**Expansion of Research and Residential Facilities for  
The Swire Institute of Marine Science, Faculty of Science,  
The University of Hong Kong at Cape d' Aguilar, Shek O, Hong Kong  
Submission of Monthly Environmental Monitoring and Audit Report No.39**

**MONTHLY ENVIRONMENTAL MONITORING AND AUDIT  
(EM&A) REPORT (NO. 39)**

**Expansion of Research and Residential Facilities for the Swire Institute of  
Marine Science, The University of Hong Kong at Cape D'Aguiar, Shek O**

**Plate 1.** Photographic records of the six recorded plants species of conservation importance.

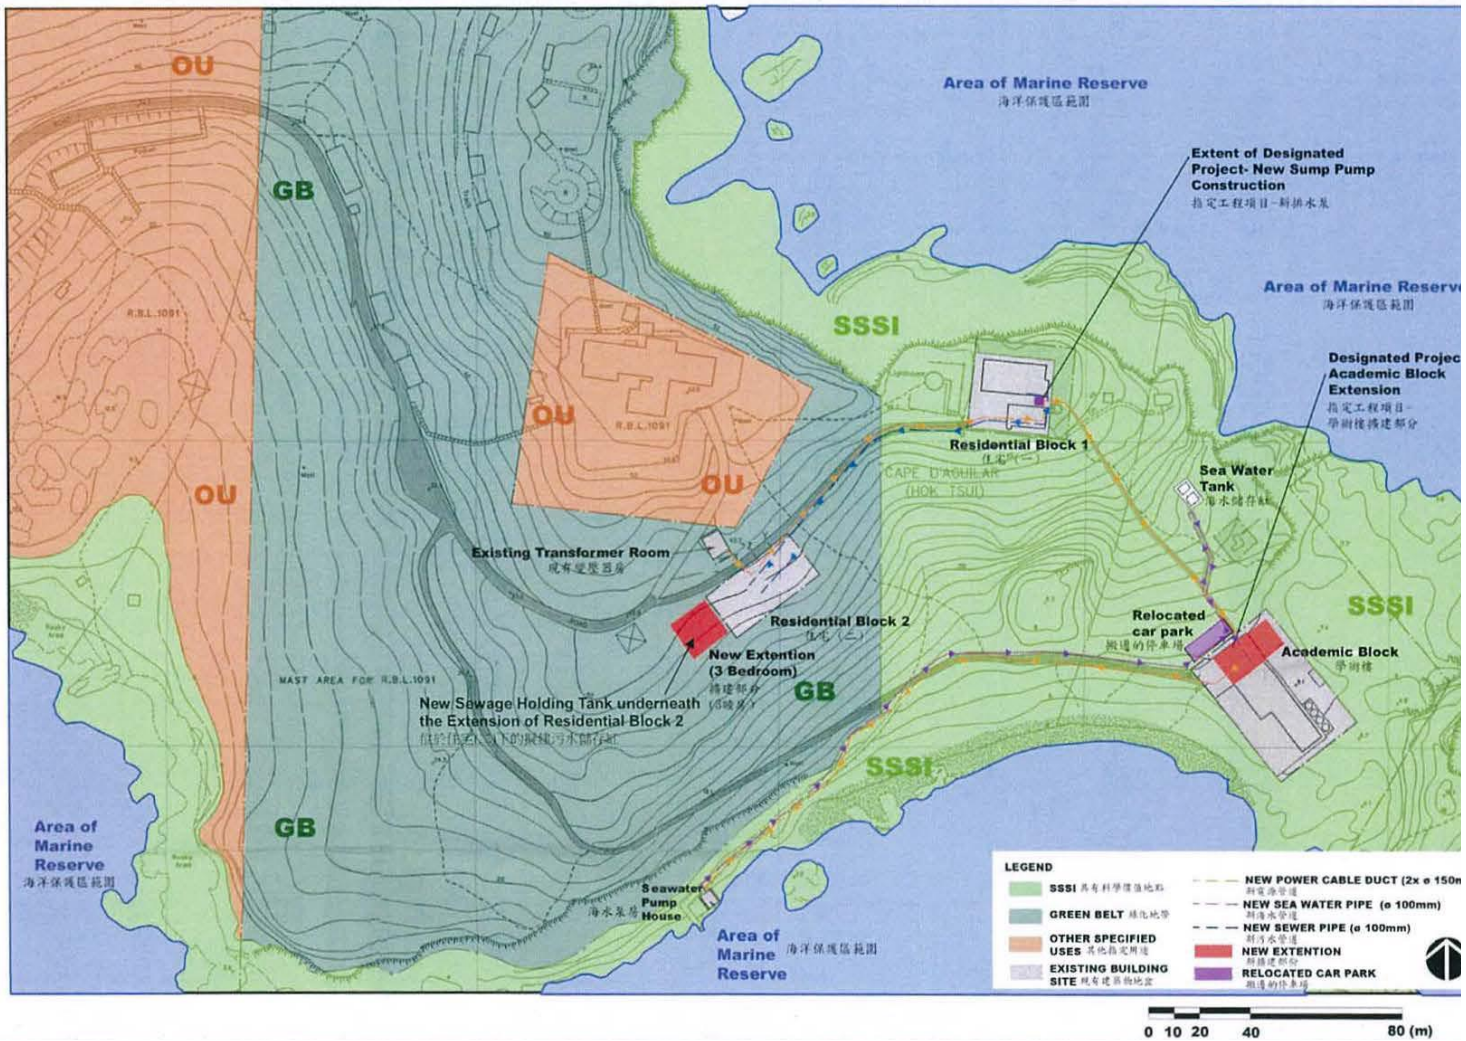
<p><i>Pavetta hongkongensis</i> 香港大沙葉</p>	<p>Fallen signage to be rectified</p>

<p><i>Millettia oraria</i> 香港崖豆藤</p>	<p>Collapsed fencing to be rectified</p>

Collapsed fencing to be rectified

Collapsed fencing to be rectified

Plate 2: Photographic updates of the three retained trees that close to construction activities .

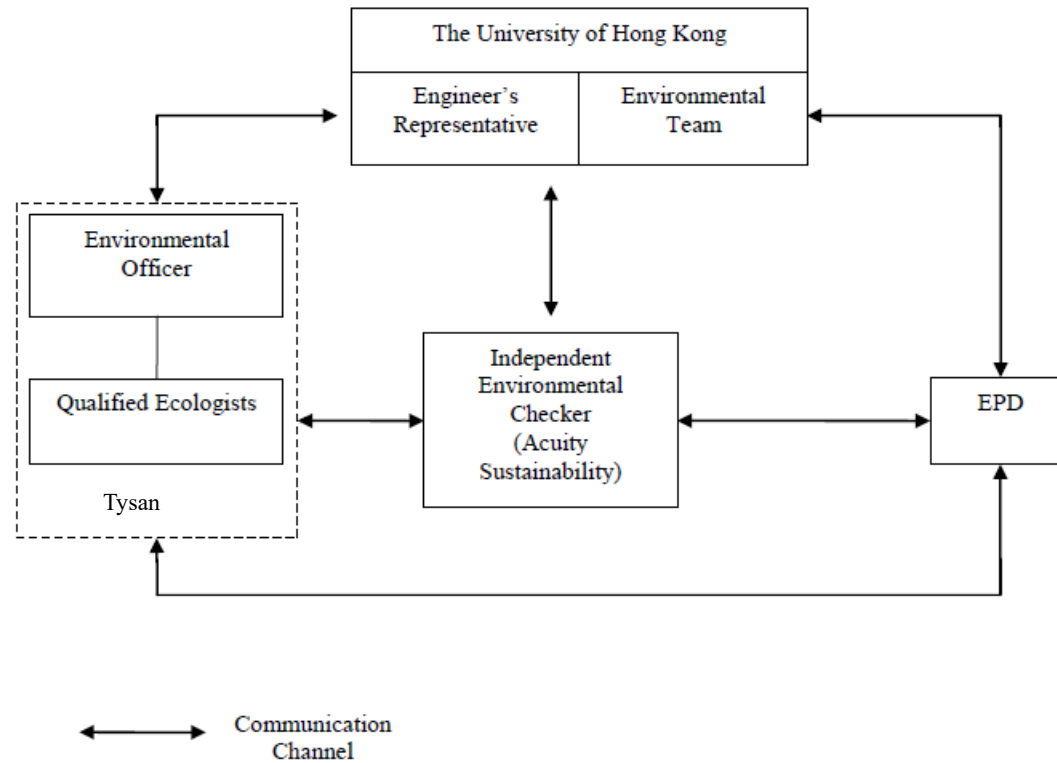
- 2.4.8. Most leaves of the deciduous *Vitis bryoniifolia* (蘼薺) has dropped.
- 2.4.9. For the three retained trees, there is no change in overall condition of T5; while regeneration of new foliage made tree health of T6, as well as tree form of TA to be assessed from poor to fair. Broken branches in TA due to the typhoon damage should receive appropriate assessment and treatment. Corresponding photographic records of T5, T6 and TA are illustrated in **Plate 2**.

<p>24/12/2020</p>	 <p>24/12/2020</p>
<p>No change in condition of T5 from previous monitoring.</p>	<p>No change in condition of T6 from previous monitoring.</p>
 <p>24/12/2020</p>	 <p>24/12/2020</p>
<p>No change in condition of TA from previous monitoring.</p>	<p>Decaying branch hanger on TA.</p>
